DATE: June 7, 1971

SUBJECT: Cabin Floor Inspection and Modification

SERIALS AFFECTED: AA1-0001 thru AA1-0457
AALA-0001 thru AALA-0123

Figure 1. PK Screw Locations

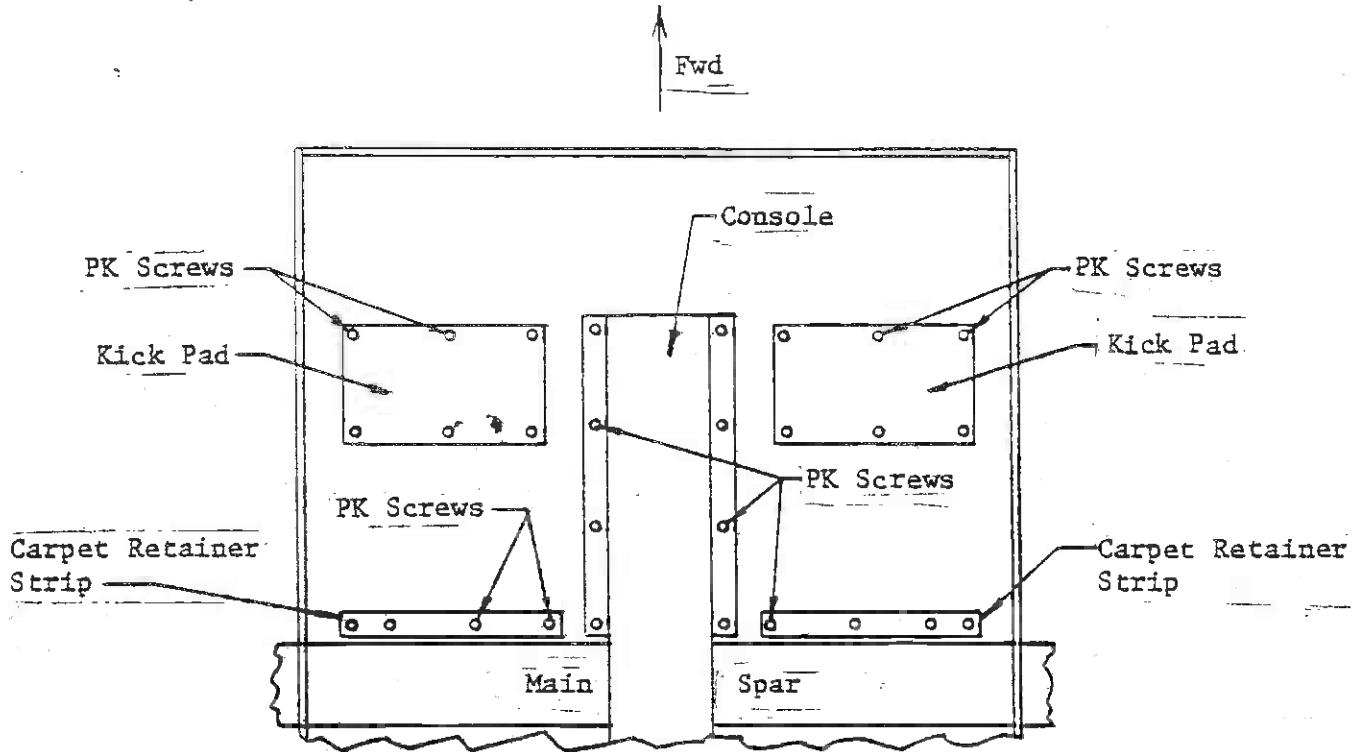
It is recommended all PK screws in the cabin floor forward of the main spar (Figure 1) be removed, one at a time, and the holes be drilled through the bottom skin from the top using a #40 (.098") drill. This will allow any water entering around the PK screws to drain. After drilling each hole through bottom skin, reinstall the PK screw before proceeding to next screw. This will help maintain alignment and prevent possible enlargement of the screw holes. After all screw holes have been drilled through bottom skin, insert the shank end of the #40 drill in the hole from underneath and push drill aft to provide a lip on the forward edge of hole. (See Figure 2).

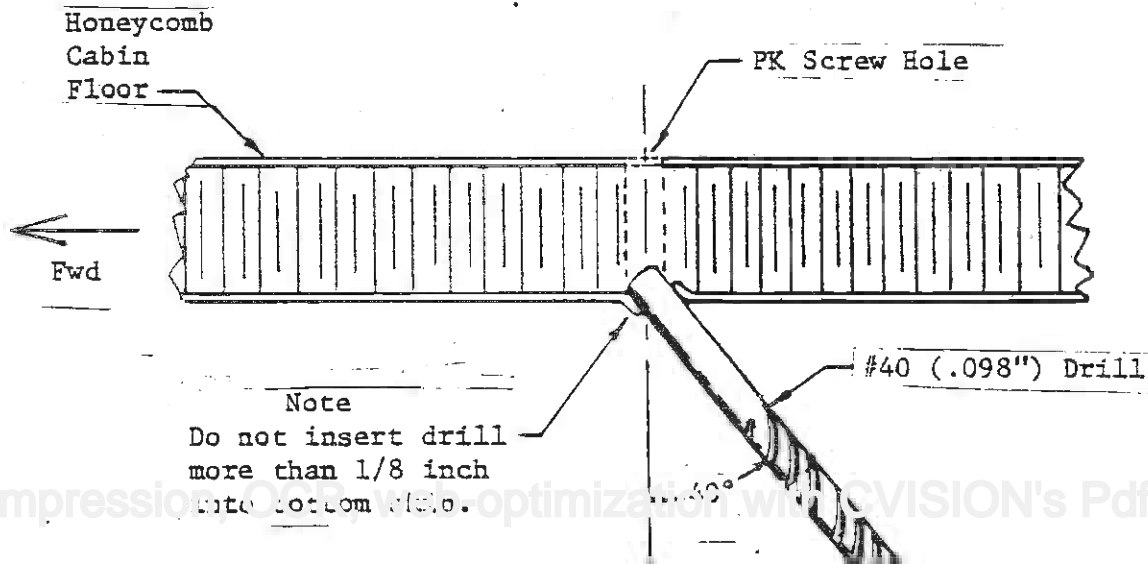
Do not extend shank of drill into honeycomb more than 1/8 inch. Use care in performing this operation to prevent delaminating the honeycomb.

Note
Do not insert drill
more than 1/8 inch
into bottom rib.
